**Darlington Public School Redevelopment (SSD-9914)  
Request for Response to Submissions**

**RE: RESPONSE TO SUBMISSIONS  
DARLINGTON PUBLIC SCHOOL REDEVELOPMENT (SSD-9914)**

**Figure 1 Amended Student Bicycle and Scooter Parking Layout**

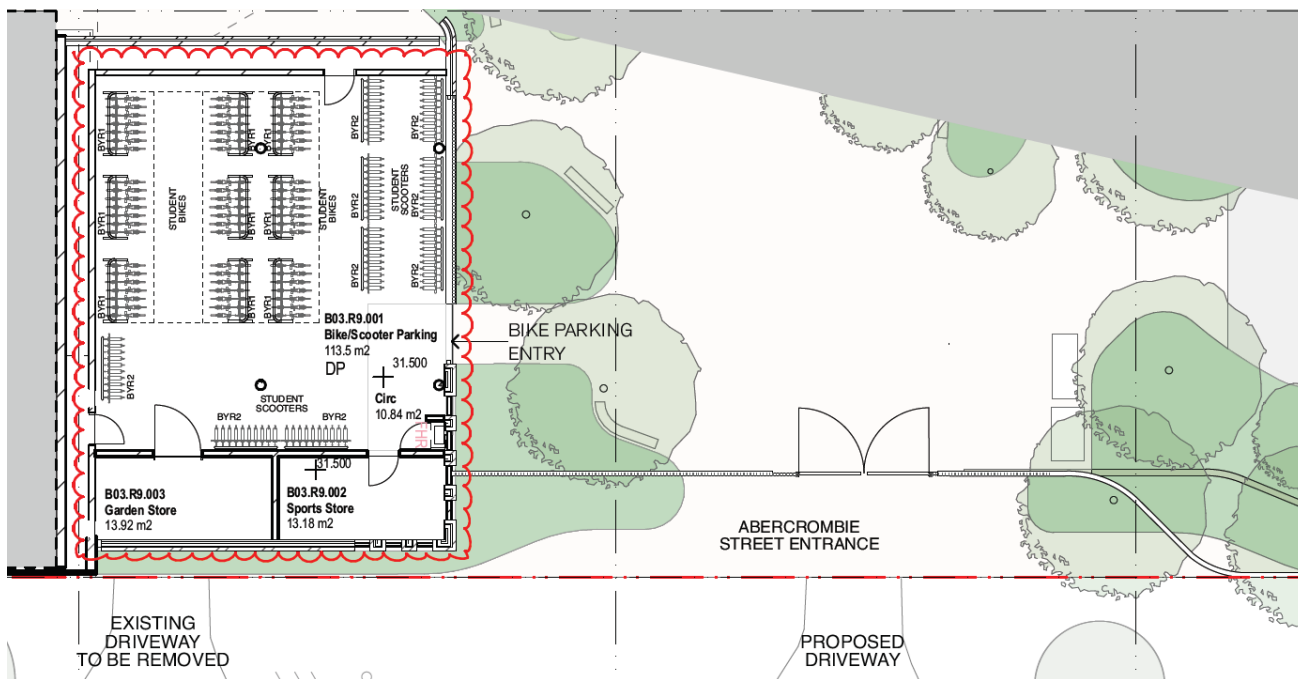
Insufficient bicycle and scooter parking provided for the expected future population of the school.

The amount of student bicycle and scooter parking has been increased from 67 spaces to 145 spaces. This is comprised of 63 bicycle parking spaces and 82 scooter spaces in a single, dedicated storage area adjacent to the Abercrombie Street entrance (**Figure 1**). This equates to 35% of the future student population of the school. Since the target mode share for the future student population is 35% of students riding/scootering to school, as outlined in the Green Travel Plan provided with the EIS (Section 9.0 of Appendix L), the increased provision is sufficient to accommodate the future population of the school, considering the target mode share.

**Figure 2 Proposed Parking Arrangements – Signage Plan**

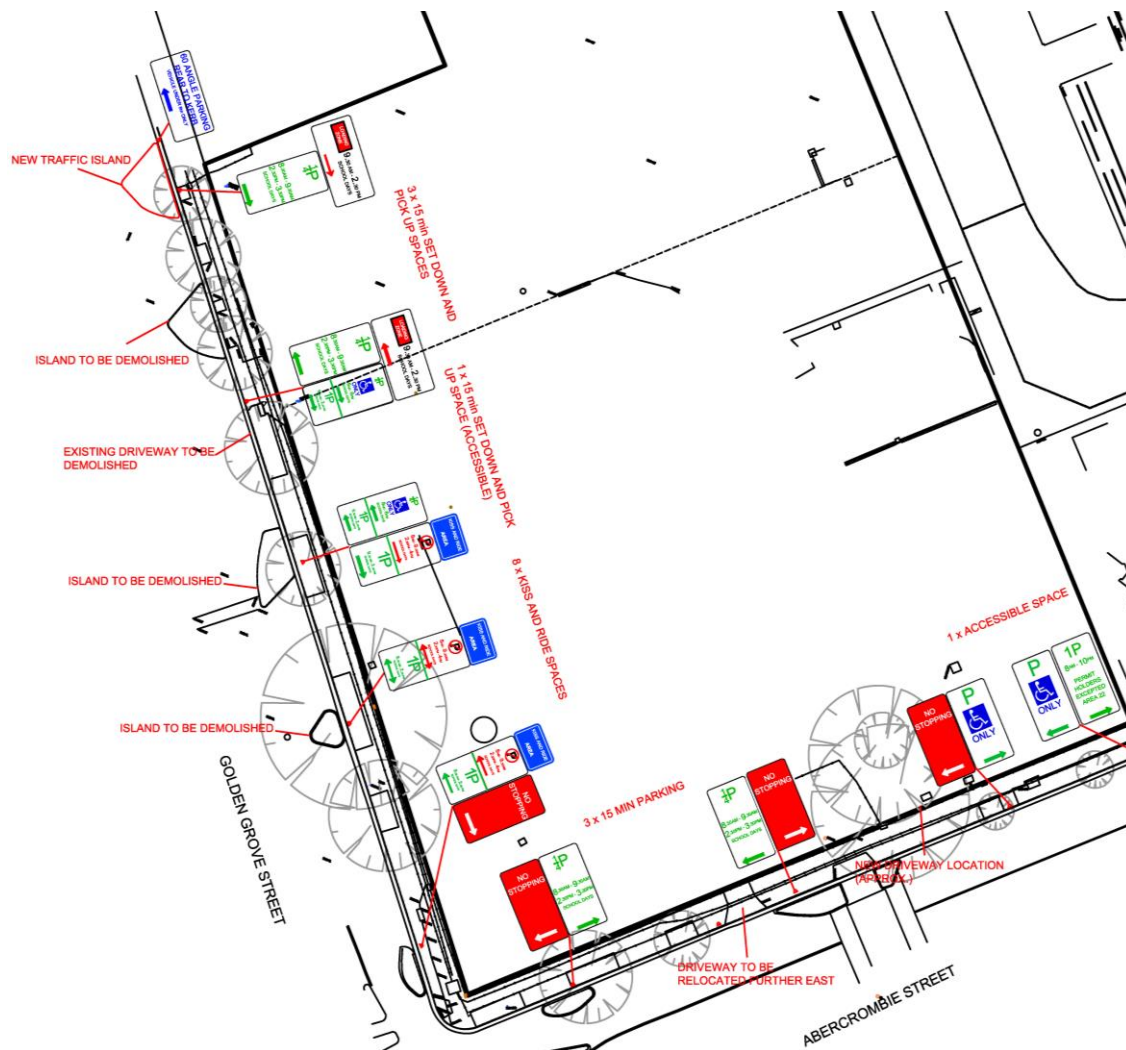
The description of the proposed pick-up and drop-off arrangement is inconsistent between the submitted EIS, Architectural Plans and Transport Impact Assessment. Clarify the proposed configuration.

The proposed pick-up and drop-off configuration is shown in **Figure 2** ('Fig 6' in the Transport Impact Assessment submitted as Appendix L to the EIS) and described as follows:

- Golden Grove Street
  - 8x Kiss and Ride only (parents remain in car) spaces between 8.30am and 9.30am and 2.30pm and 4.30pm on school days. Spaces are 1hr parking between 9.30am and 2.30pm.
  - 3x 15 minutes parking between 8.30am and 9.30am and 2.30pm and 4.30pm on school days. Loading Bay between 9.30am and 2.30pm on school days to serve the needs of service vehicles and/or excursion buses
  - 1x accessible 15 minutes parking between 8.30am and 9.30am and 2.30pm and 4.30pm on school days. 1hr parking between 9.30am and 2.30pm.
- Abercrombie Street
  - 3 x 15 minutes parking between 8.30am and 9.30am and 2.30pm and 4.30pm on school days
  - 1x accessible parking space.

An amended Upper Ground Level Plan is provided at **Attachment A** which correctly reflects this arrangement. The above description supersedes the description provided in the submitted EIS and Transport Impact Assessment.
